ADDENDUM NO. 3 – July 15, 2026

Mossdale Wastewater Pump Station Access Modifications and Upgrades CIP WW 26-09

This addendum amends the Contract Drawings and Specifications for this project as follows:

8
C-101 BYPASS SEWER MANHOLE
SCALE: 1"=1'-0"

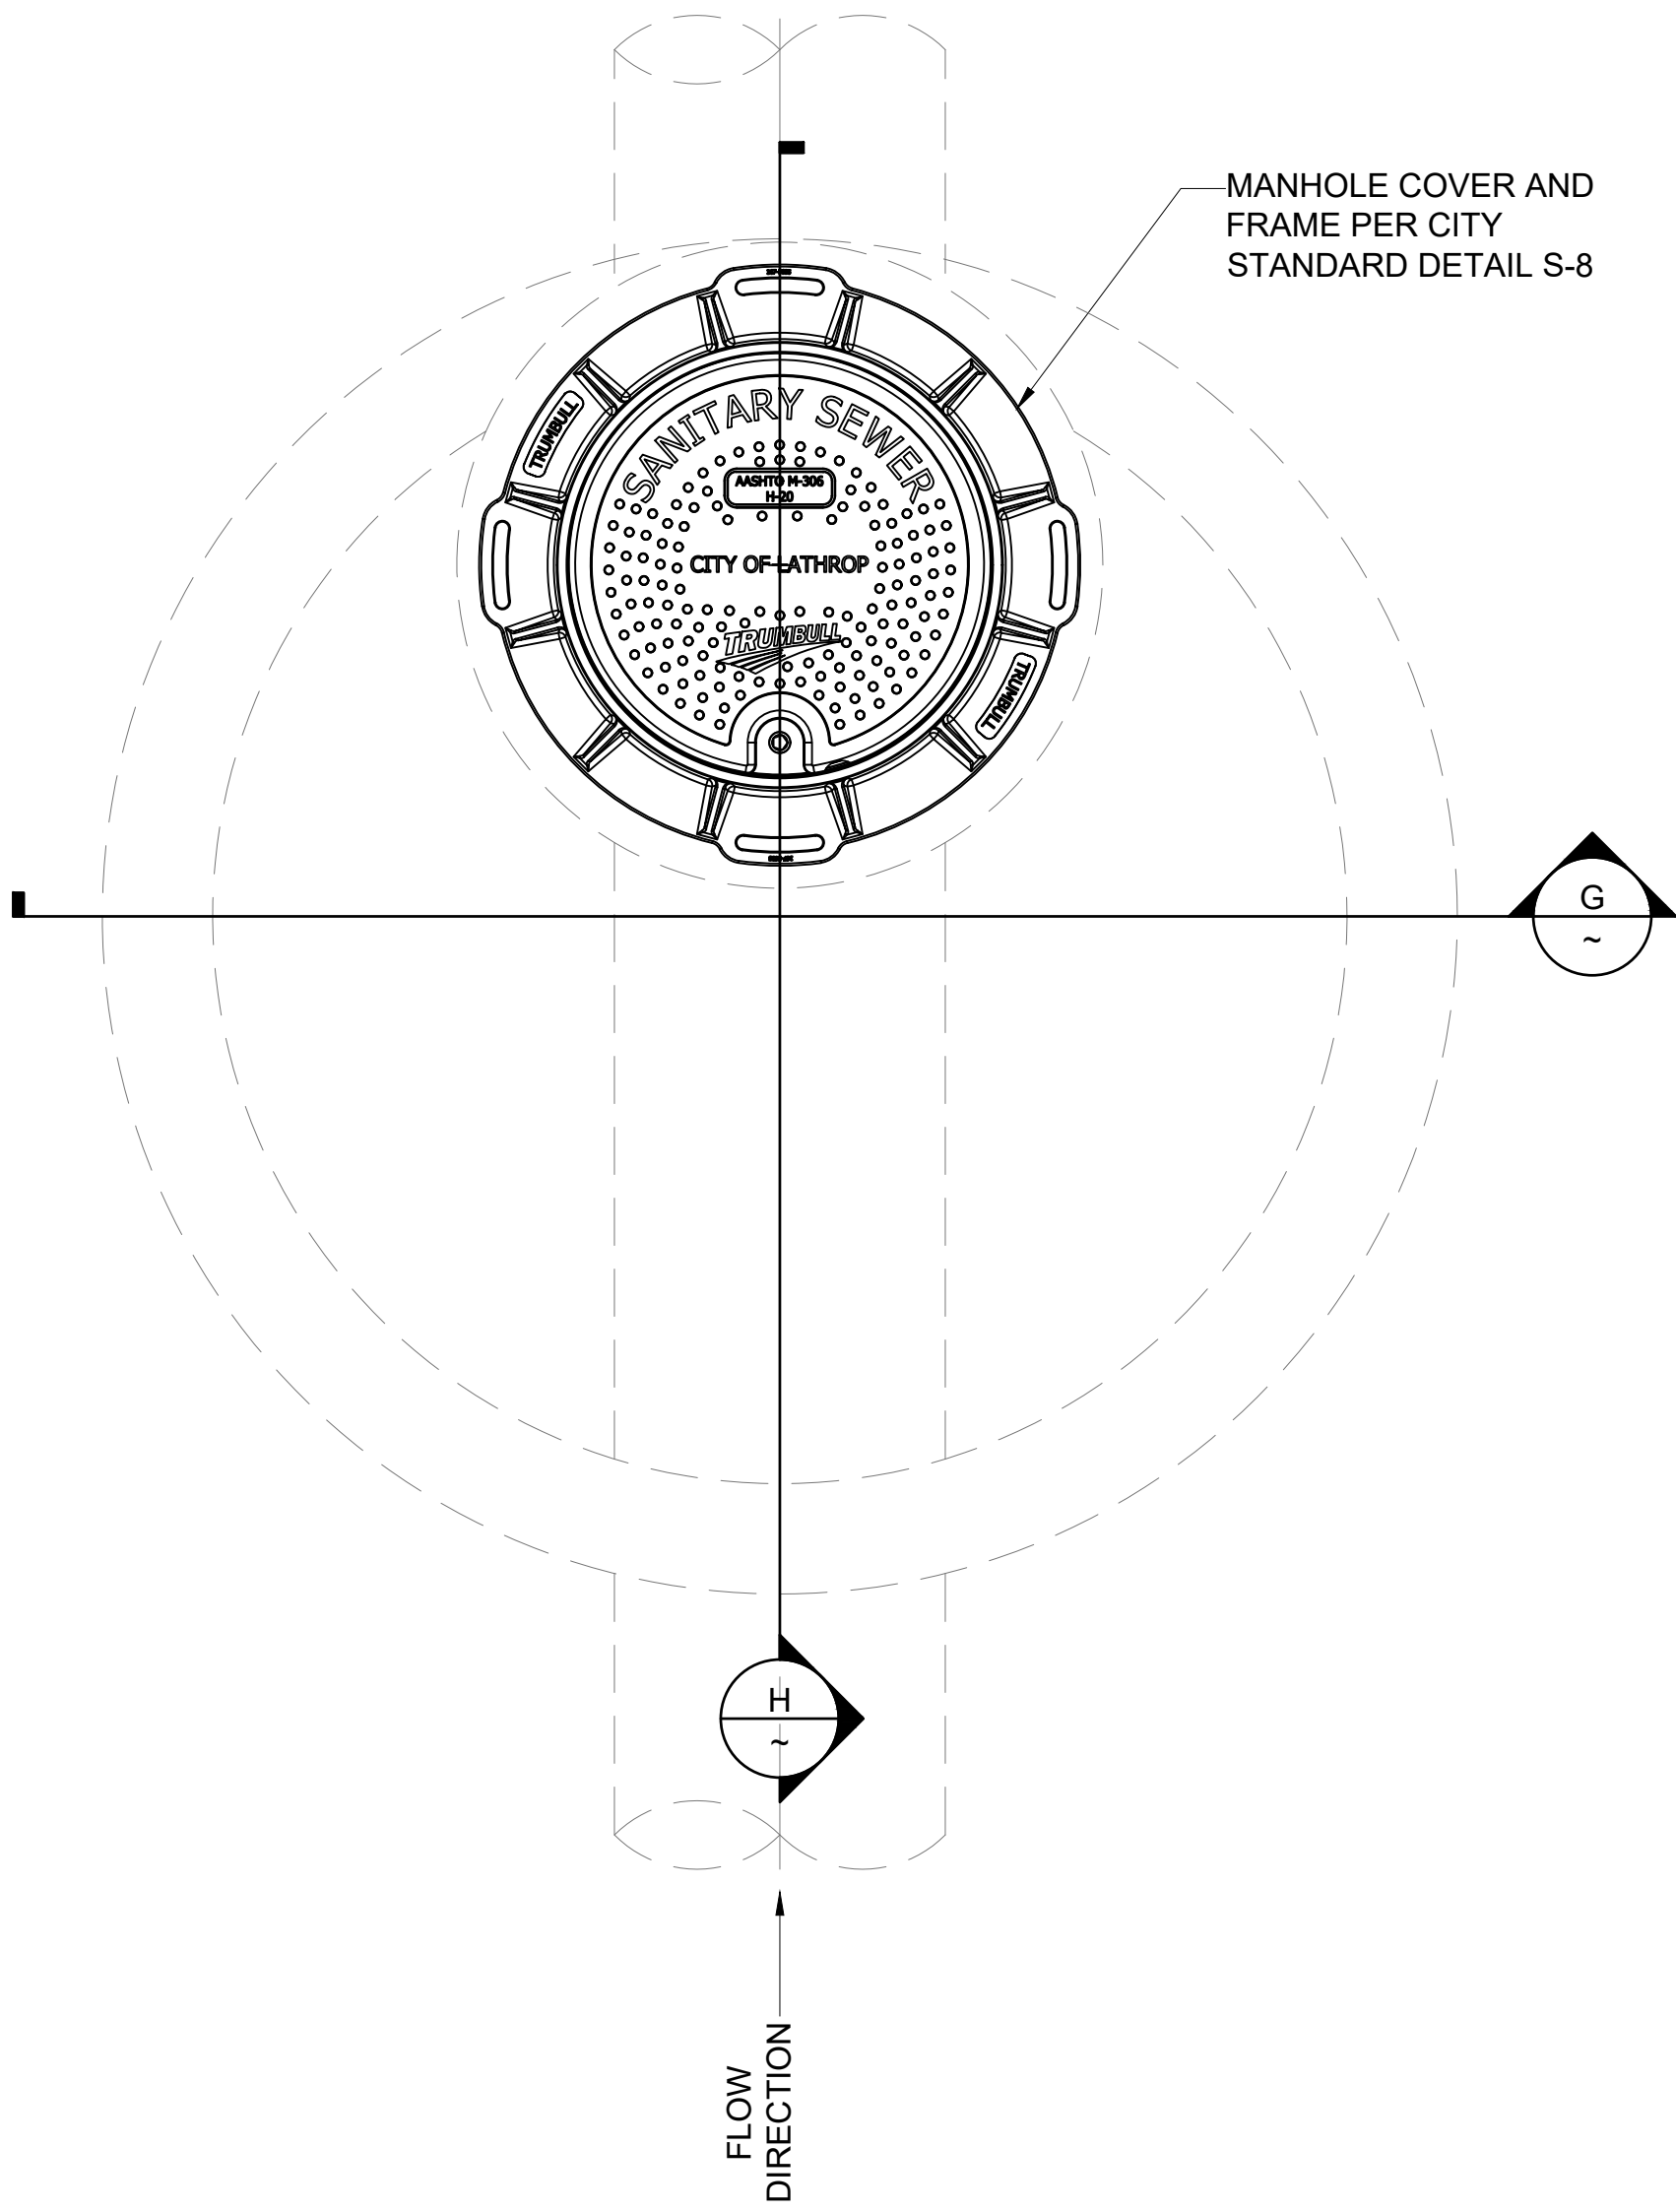
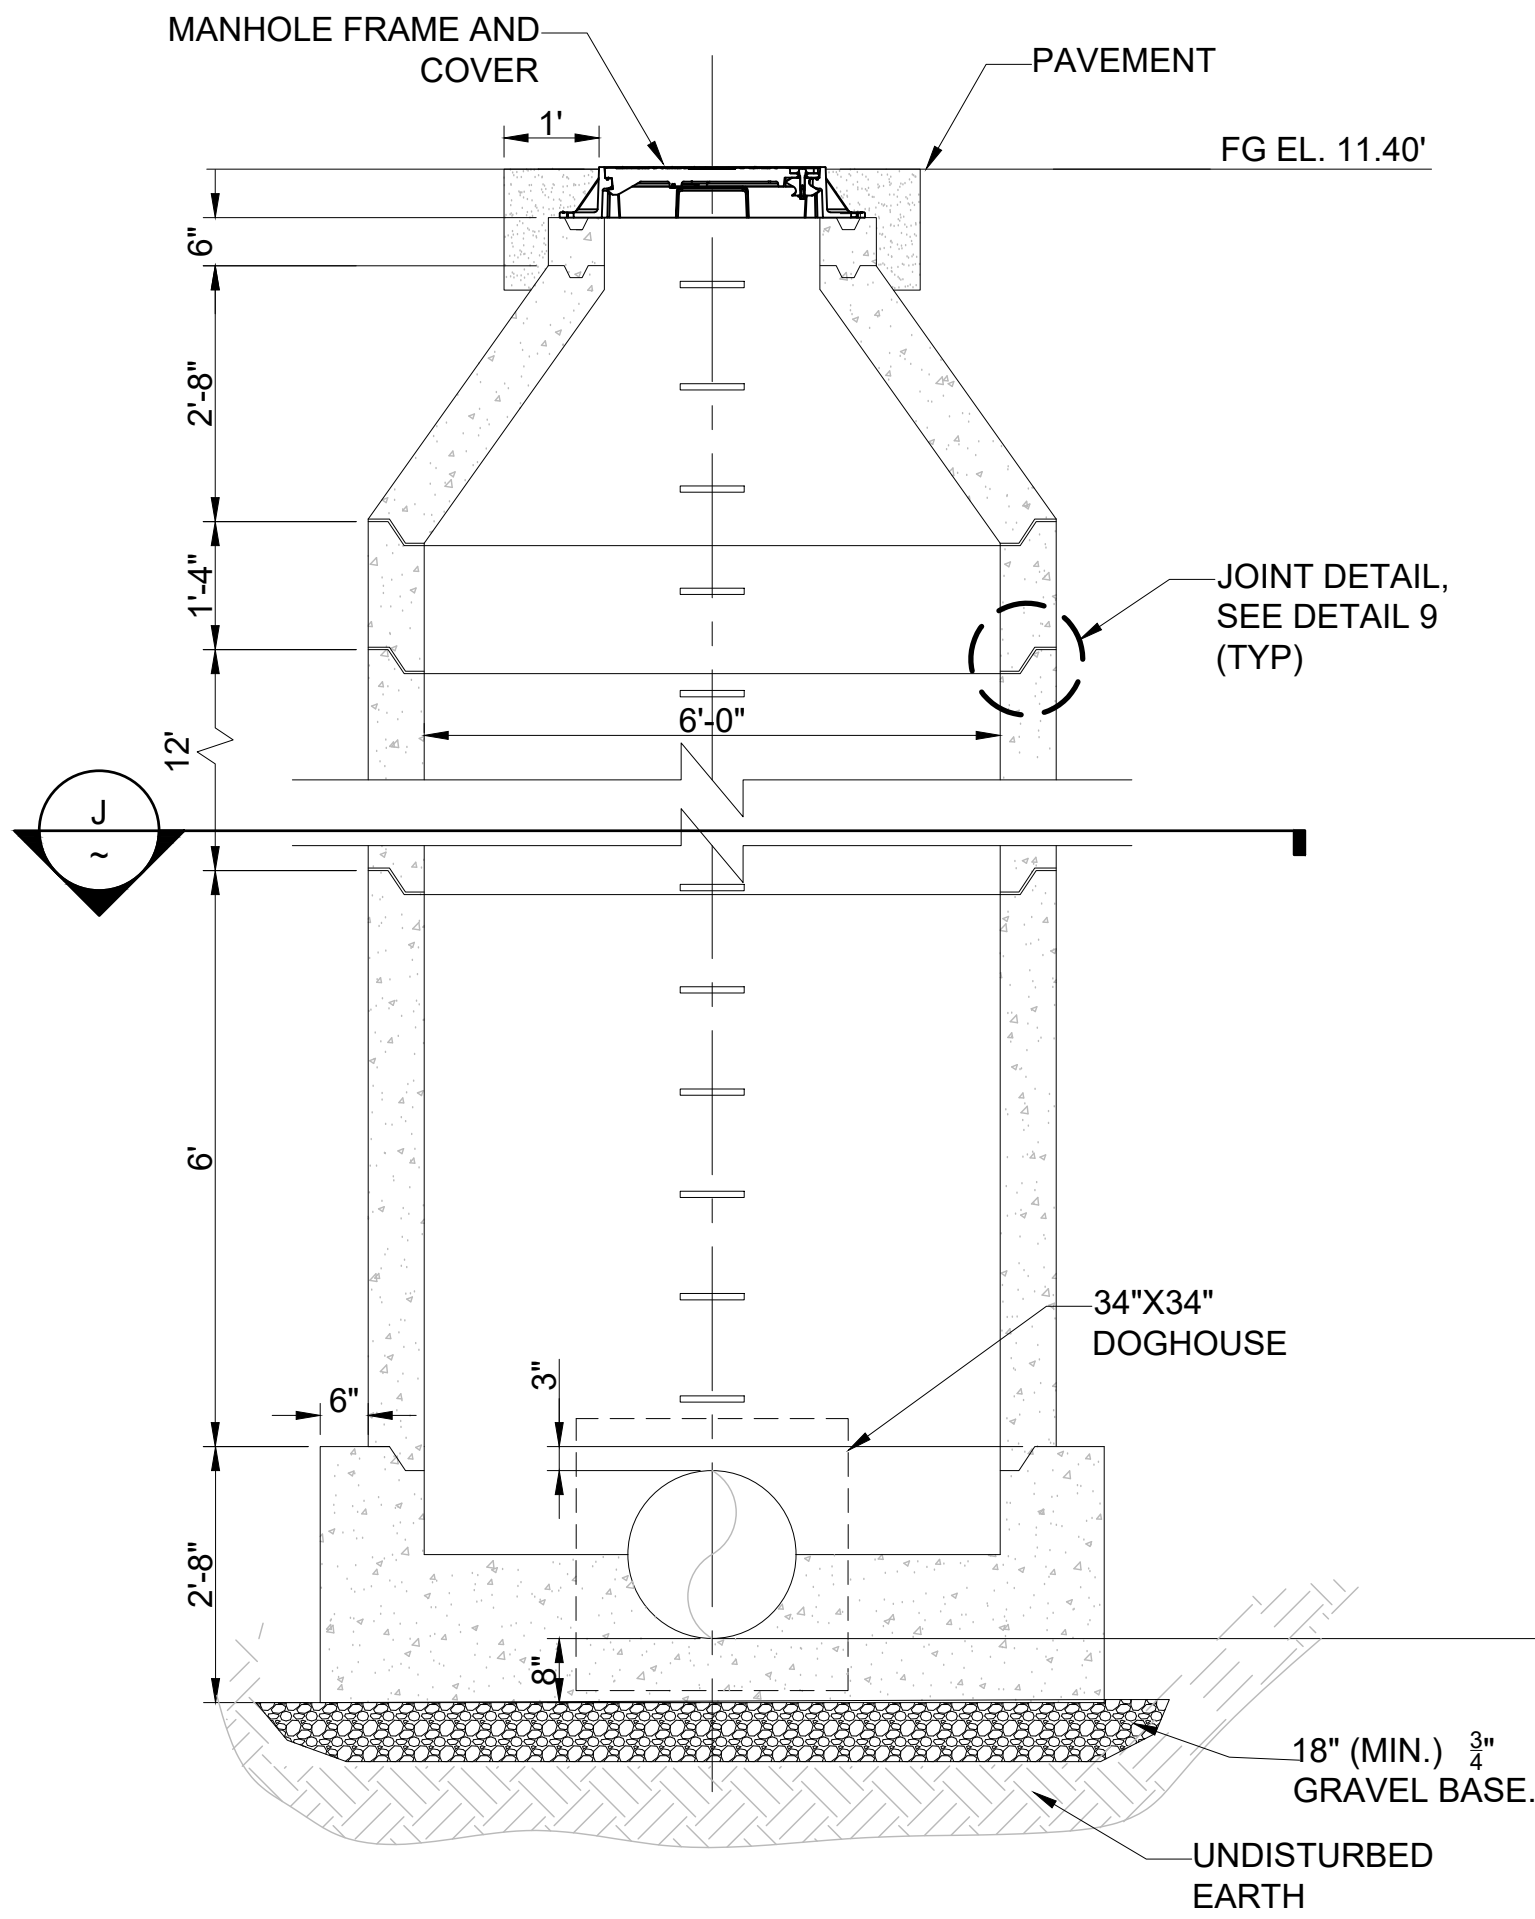
1. See Attachment A, new and amended plan sheets for construction of a bypass with manhole.
2. See Attachment B, new and revised Bidding and General Requirements and Technical Specifications for the construction of a bypass and manhole.
3. See Attachment C, Revised Bid Schedule, CIP WW 26-09. **All bids must be submitted on the revised bid schedule.**
4. Contract Time: The Contract Time is increased by 75 working days, for a revised total of 150 working days.
5. Supplementary Conditions 00800-2 and 00800-3 are revised as follows:

- ASSUMPTION: DISTANCE FROM INVERT AT PUMP STATION TO MH LOCATION: 16'-2" @ 2% SLOPE $\approx$ 0.325'. PIPE INVERT ELEVATION @ MANHOLE = -13.605'. ACTUAL PIPE SLOPE UNKNOWN. NEW MH ELEVATION SHALL PROVIDE FOR POSITIVE FLOW THROUGH TO PUMP STATION.

- BYPASS SANITARY SEWER MANHOLE SHALL BE CONSTRUCTED IN ACCORDANCE WITH CITY STANDARD DRAWING S-1.
- PRECAST REINFORCED CONCRETE MANHOLE UNIT SHALL CONFORM TO ASTM C-478.
